**Re: GE-Pittsfield/Housatonic Site Upper ½-Mile Reach Removal Action:
Response to Questions/Comments on DNAPL Proposal**

UPPER ½-MILE REACH REMOVAL ACTION

**CONCEPTUAL DESIGN FOR THE INSTALLATION OF A DNAPL RECOVERY
SYSTEM**

ATTACHMENT 1

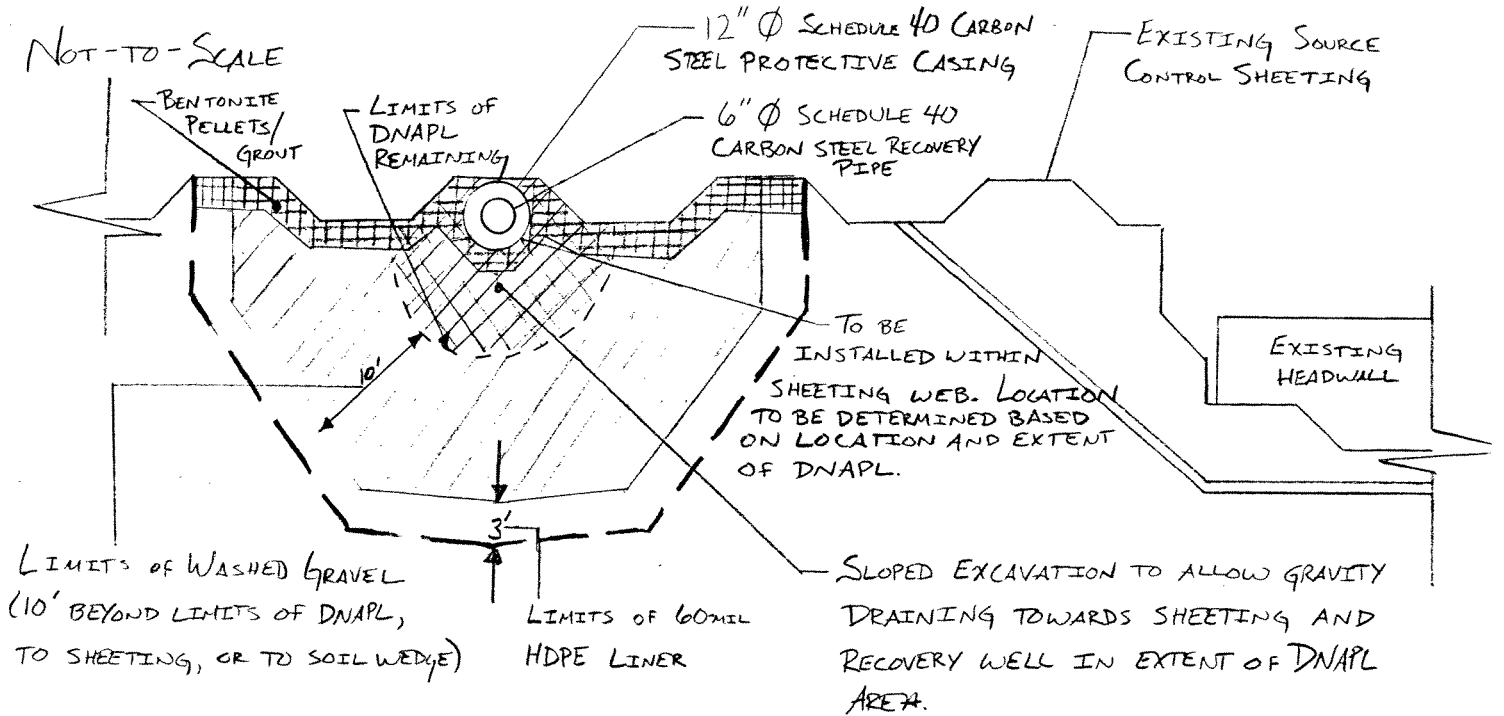
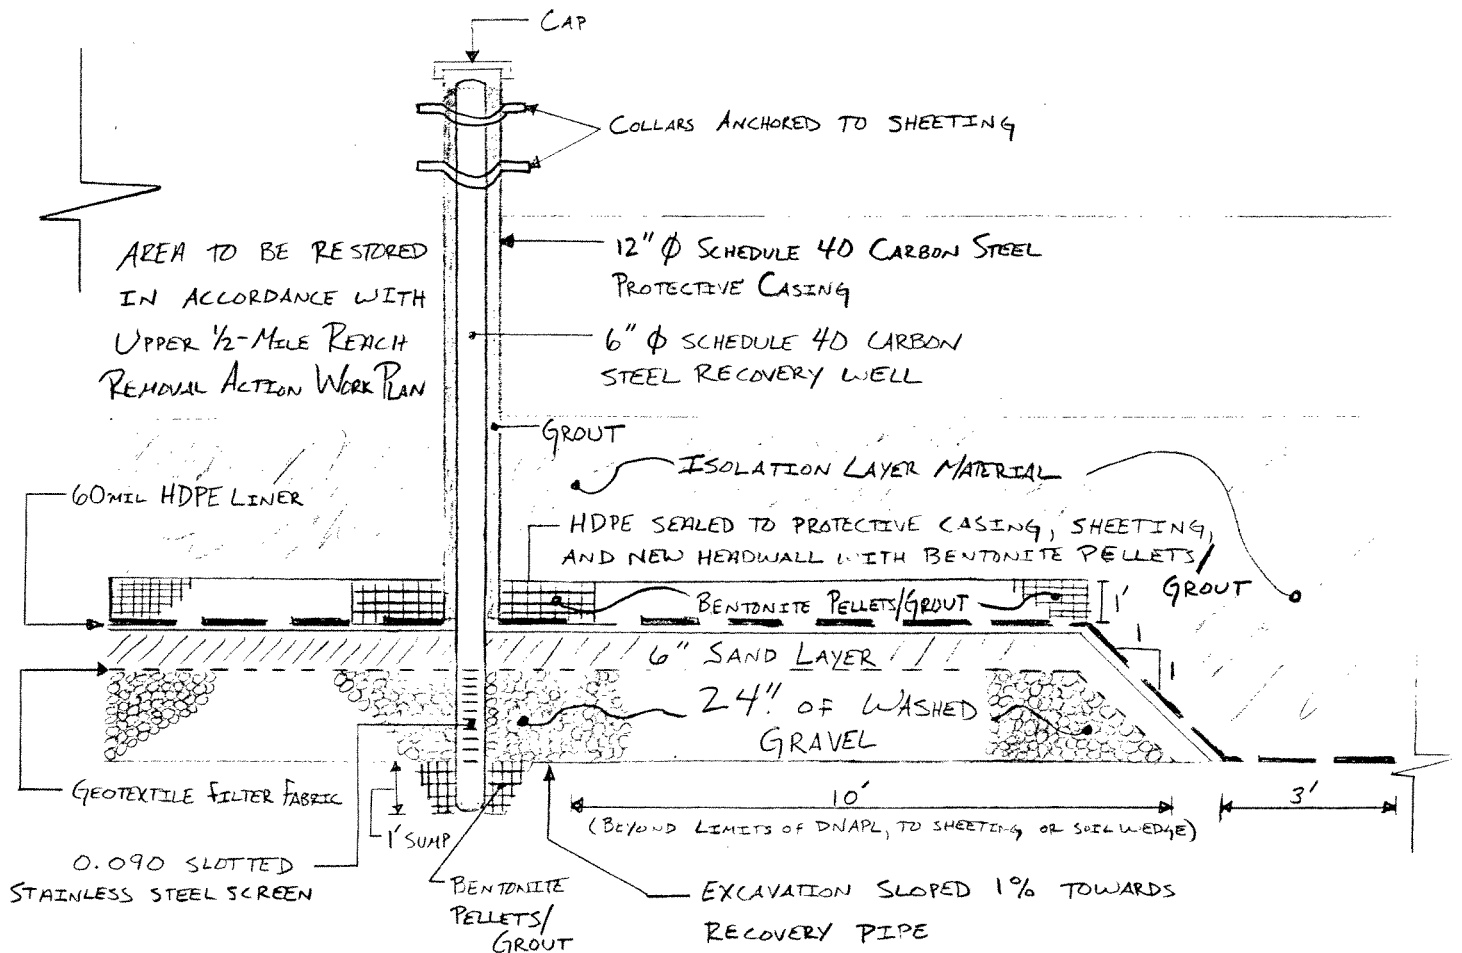
In response to the above referenced EPA comment, this document presents a conceptual design for the installation of a DNAPL recovery system, as a contingency to the DNAPL excavation plan for the Cell C area.

In the event that DNAPL or DNAPL-impacted material remains following excavation activities and the extent of the impacted area extends to the source control sheeting, a recovery system consisting of a 6-inch diameter recovery pipe with a 12-inch diameter protective casing and stone drainage layer will be constructed within the DNAPL area (see Attachment 1). The base of the excavation within the extent of the area where DNAPL remains will be sloped (approximately 1 percent slope) to allow gravity drainage of DNAPL toward the recovery pipe. For the recovery pipe, a 1-foot sump will be excavated and an approximate one-foot length of solid 6-inch diameter pipe will be placed. The hole around the sump will be filled with bentonite pellets or cement/bentonite grout and a 2-foot-long 0.090-slotted screen will be placed above the sump. Approximately 2-feet of gravel will be placed, around the screened section. As a

conservative measure, the stone will be placed approximately 10 feet on each side of the maximum horizontal extent of the DNAPL remaining or until contact with the sheeting (or to any wedge of soil that remains in contact with the sheeting, within the removal area, for excavation stability). Following placement of the gravel, a geotextile filter fabric and a 6-inch sand layer will be placed. Above the sand layer, a 60-mil high density polyethylene (HDPE) liner will be placed and extended approximately 3 feet on each side of the maximum horizontal extent of the sand layer. In the event that the HDPE liner is placed in sections, these sections will be welded in accordance with manufacturer specifications and/or recommendations. Also, the HDPE liner will be sealed around the 12-inch diameter protective casing, the sheeting, and the new concrete headwall, as required, using an approximate 2-foot wide, 1-foot thick layer of bentonite pellets or cement/bentonite grout. The protective casing, along with the recovery pipe, will stick-up approximately 2 feet above final grade. The protective casing will be anchored to the sheeting using pipe collars and will also be threaded at the top so a cap will be able to be placed/removed, as necessary to remove DNAPL and protect the recovery pipe during a high flow event. The annulus between the 12-inch diameter protective casing and the 6-inch diameter recovery pipe will be filled with grout. Isolation layer material (i.e, the finer grain material originally approved) will be placed above the HDPE liner and the remainder of the area will be restored in accordance with the provisions set forth in the Upper ½-Mile Reach Removal Action Work Plan (BBL, August 1999).
